## **Comments on: National Pollutant Discharge Elimination System (NPDES) General Permit for Discharges of Storm Water Associated with Construction and Land Disturbance Activities**

### CBIA Coalition's Technical Comments: Executive Summary

Figure 1. Relations between turbidity and total suspended solids (TSS) in storm water runoff in Orange County, CA: N=601.

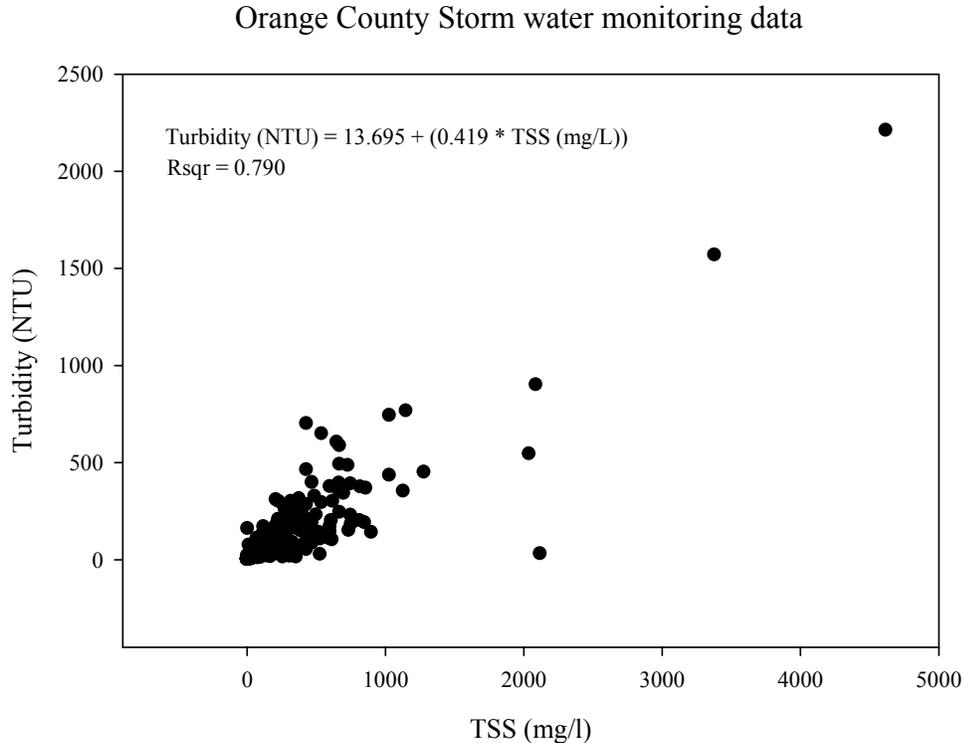
Third, the assumption of a 1:3 ratio for NTU: SSC has no scientific basis. Numerous studies have examined the ratio between suspended solids concentration and turbidity, mostly using total suspended solids concentrations (TSS). Although several authors have attempted to correlate turbidity measurements with the gravimetric measurements of TSS (Schroeder et al. 1981; Schubel et al. 1978; Schubel et al. 1979), a consistent relationship has not been established. Correlations are generally site-specific and may change over the course of a year, although not in a consistent fashion (Manka 2005). The suspended sediment-turbidity relationship shifts between the rising and falling limbs of the hydrograph, meaning that the ratio will differ at different times during a storm event. (Knighton 1998). Variability in the NTU-TSS correlations can be attributed to differences in size, composition, and refractive index of particles (Earhart 1984). For dilute solutions, there appears to be a linear relationship between the amount of light scattered and the amount of suspended material, but when TSS levels are high, light cannot penetrate the sample and will distort the turbidity reading (Schubel et al. 1978).

Orange County storm water monitoring program<sup>3</sup> has been collecting TSS and turbidity data in storm runoff for years. Available data are from 599 samples that were collected from 21 storm water monitoring stations across four watershed (i.e., Newport Bay, San Diego Creek, Santa Ana River, and Westminster) in Orange County from October 2000 to May 2006. The Orange County storm water data show that the NTU:TSS relationship 1:0.03 to 1:71, depending on different stations and different storm events, indicating that the assumption that a 1:3 relationship exists between turbidity and SSC is suspect and represents a serious oversimplification. The linear regression analysis of the Orange County Data shows the regression of “Turbidity (NTU) = 13.7 + (0.42\* TSS(mg/L))”, which is roughly translated to 1:14 NTU:TSS (Figure1).

Figure 2. Relation between turbidity and suspended-sediment concentration for two urban streams located in Gwinnett County, Georgia. Source (Ankcorn 2003)

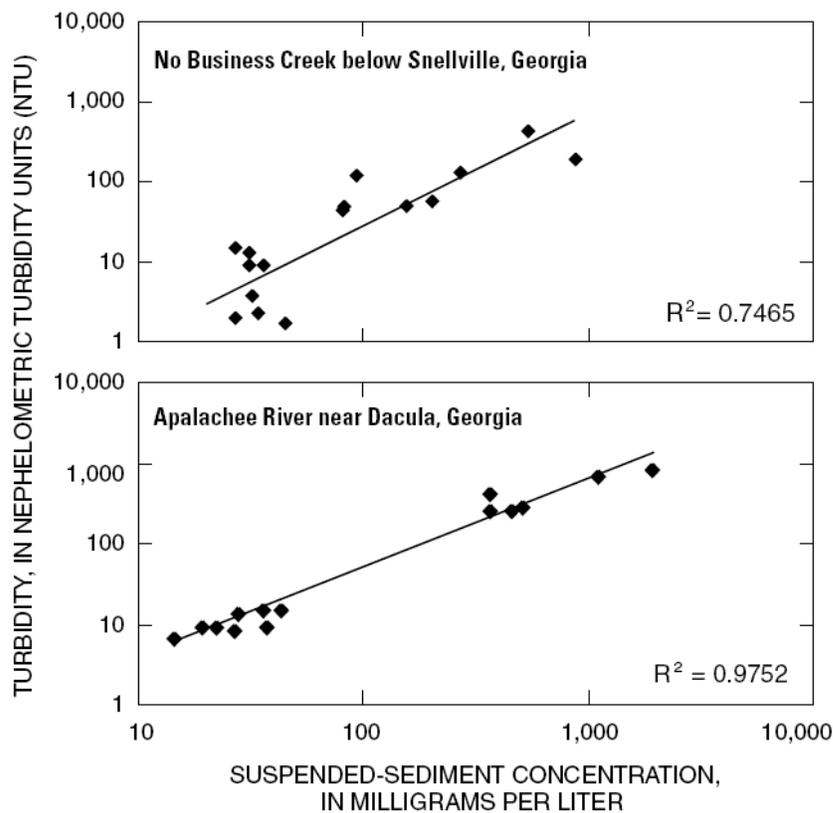
These considerations also apply to SSC. Ankcorn (2003) attempted to estimate the ratio for turbidity (NTU) and SSC using USGS data at two streams in Gwinnett County, Georgia. The ratio shown in the Figure 2. is far from 1:3.

Figure 3. Change in TSS concentration over the course of a storm event at Bear Creek, a tributary to North Fork Matilija, CA; From Stein and Yoon (2007)

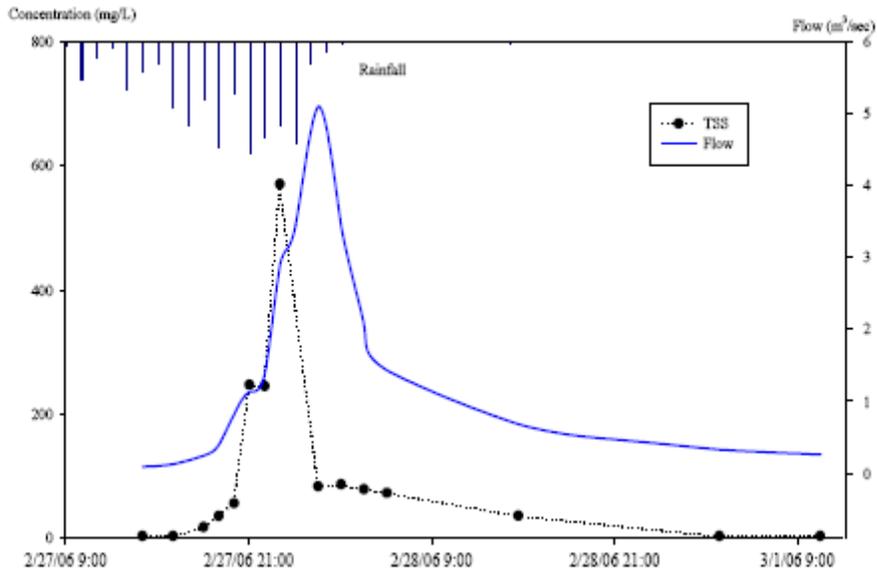
TSS concentrations in runoff from undeveloped watersheds were also observed to vary significantly during individual storm events, with peak concentrations of TSS hundreds of times higher than non-peak concentrations (see Figure 3 below) (Stein and Yoon, 2007). Stein and Yoon (2007) also showed that TSS levels in natural, undeveloped watersheds were significantly higher than at typical developed watersheds in southern California (see Figure 4 below).

Figure 4. Comparison of wet weather flow-weighted concentrations of total suspended solids (TSS) between natural and developed catchments. The white boxes represent natural catchments, and the gray box represents data from developed catchments. The Y axis is in log scale; From Stein and Yoon (2007).

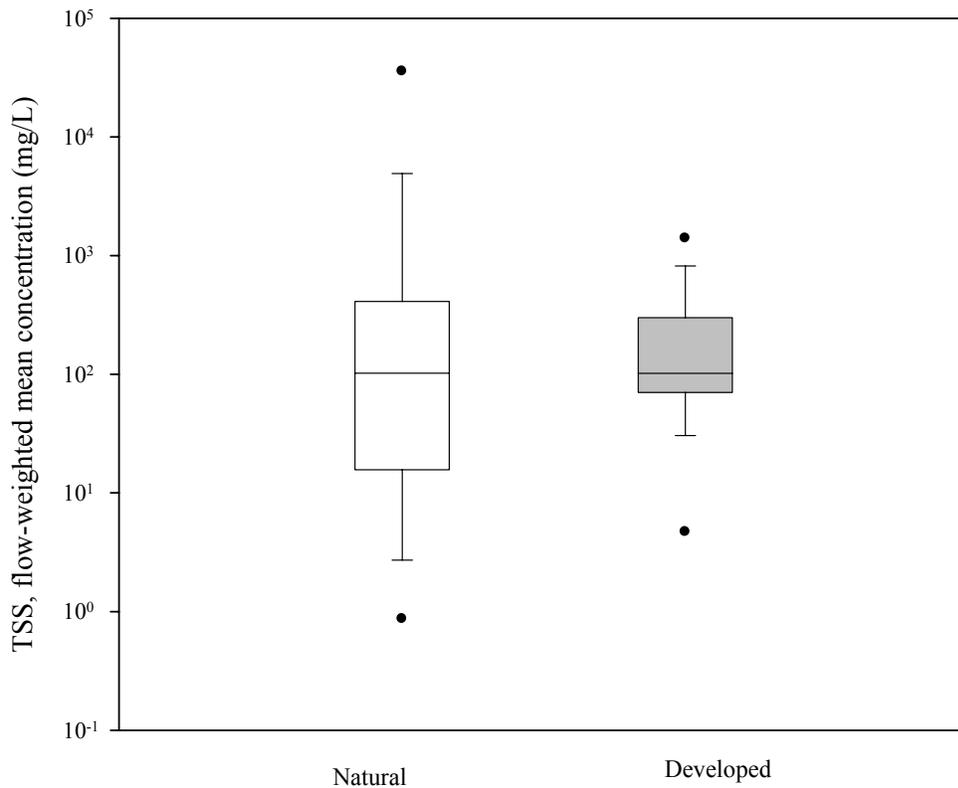
**Any NEL should be derived in consideration of natural background levels.** The proposed NEL does not appear to be calculated to consider natural background conditions. As currently written, receiving water quality is only considered if receiving water monitoring is required following an NEL exceedance. Natural background turbidity and/or TSS levels in storm water runoff vary considerably, both within different areas of the site and in response to different storm conditions (e.g., rainfall intensity, rainfall amount, antecedent conditions). Thus, it makes little sense to adopt a single NEL for turbidity that is applied uniformly throughout the state. Rather, NELs for turbidity should be established after consideration of receiving water conditions. As indicated in the BRPR at p.16 "... it is important to consider natural background levels of turbidity or TSS in setting Numerical Limits or Action Levels for construction activities. The difficulty in determining natural background concentrations/levels for all areas of the state could make the setting of Numeric Limits or Action Levels impractical from an agency resource perspective."
